AURIX™ TC37x errata sheet

Marking/Step: (E)ES-AA, AA

About this document

Figure 14 Positive overload on P-pad of a LVDS RX pin pair (both used as inputs)

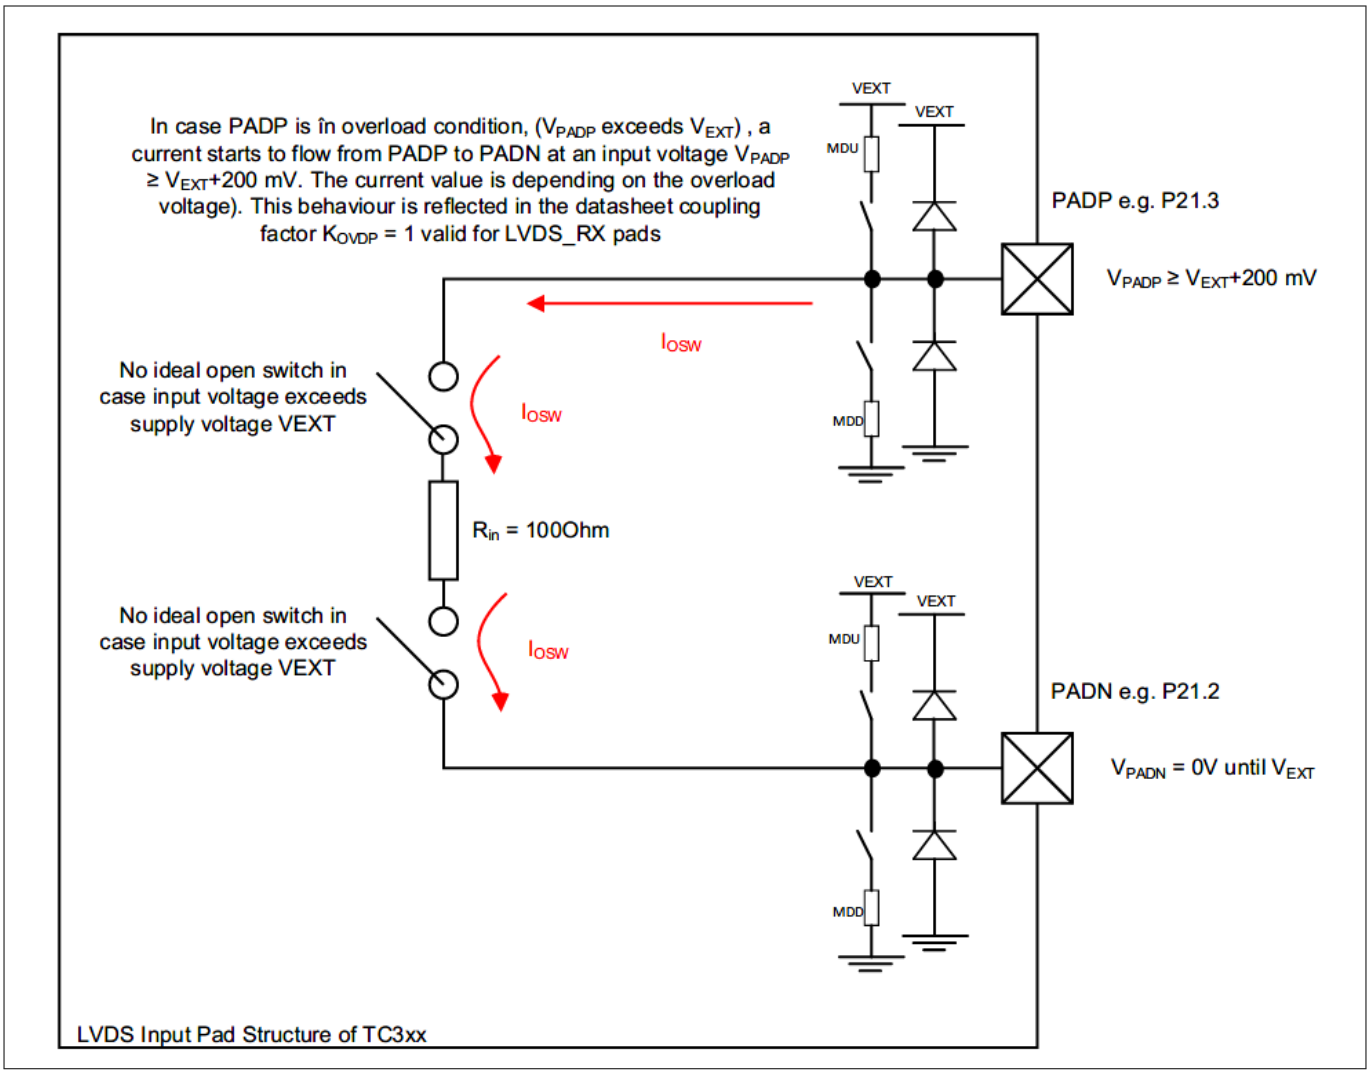
The following figure illustrates the effect for a positive overload condition ($V_{PADP} > V_{EXT}$) on the P-pad (PADP) of a pin pair where both the P-pad and the corresponding N-pad (NPAD, with $0V \le V_{NPAD} \le V_{EXT}$) are used as digital CMOS inputs.

The overload current I_{OSW} through the non-ideal open switch significantly increases when $V_{PADP} \ge V_{EXT}$ + 200 mV.

***Note**: In general, the effect will also occur if the N-pad is used as output, or for a negative overload condition on either the P-pad or the N-pad.*
